TOWN OF WARRENTON

ARCHITECTURAL REVIEW BOARD

Staff Report COA 22-35

Owner/Applicant: Ramy Hanna
Property: 22 Fisher Lane
GPIN: 6984-21-3717
Request: Exterior additions & alterations
Present Use: Dwelling
Zoning: R-15 Residential

Proposed Design: Front Porch

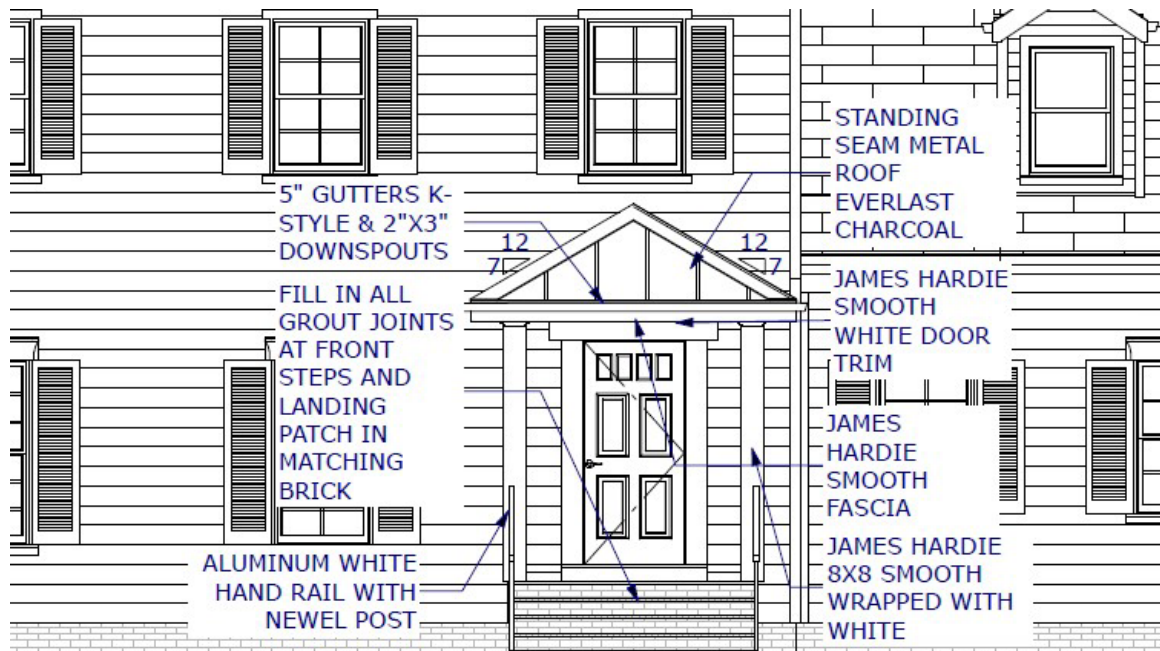
The front porch additions will have a slight impact on the main structure where the roof will need to be attached, but generally can be removed easily to revert the structure back to its original composition. The standing seam metal roof material falls within those typically seen within the historic district. The proposed aluminum handrail may have a slight impact on the character of the front entrance in comparison to the width of the wood material used for the existing handrail. Simply increasing the width of the rails and posts would mitigate this impact.

Proposed Design: Rear Porch

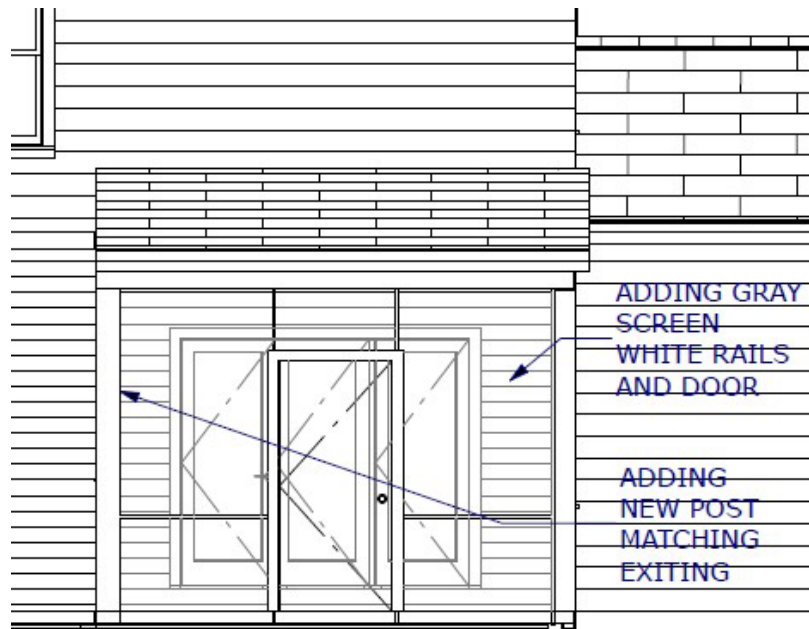
The asphalt roof replacement is in-kind and therefore has zero impact on the character of the structure and historic district. The proposed screened in porch with accompanying column will have minimal impact of the existing structure and no impact of the historic district, having no visibility from the public right-of-way.
